THE
NATIONAL
BOARD
OF BOILER AND
PRESSURE VESSEL
INSPECTORS

SUBCOMMITTEE ON INSTALLATION

AGENDA

*Meeting of January 16, 2013
Mobile, Alabama*

Figure 1

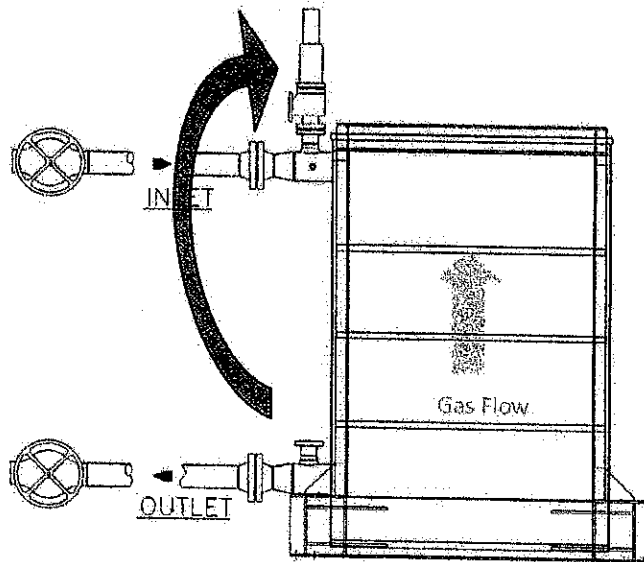
An example would be a vertical counterflow economizer where the inlet header is located above the outlet (as in Figure 1) if the designer can specify where the PSV be located then the PSV may be placed such that the release of energy, via steam, happens more slowly through the same size PSV.

Figure 1 illustrates a counter-flow economizer, in a vertical up gas path, having horizontal headers, with the outlet header below the inlet. When this type of economizer is isolated during operation, and the PSV is tripped, steam will begin to collect in the upper "inlet" header. This design allows a more controlled venting of isolatable economizers by venting steam instead of hot water. Figure 1 also illustrates moving the safety relief valve from the outlet to the preferred location.
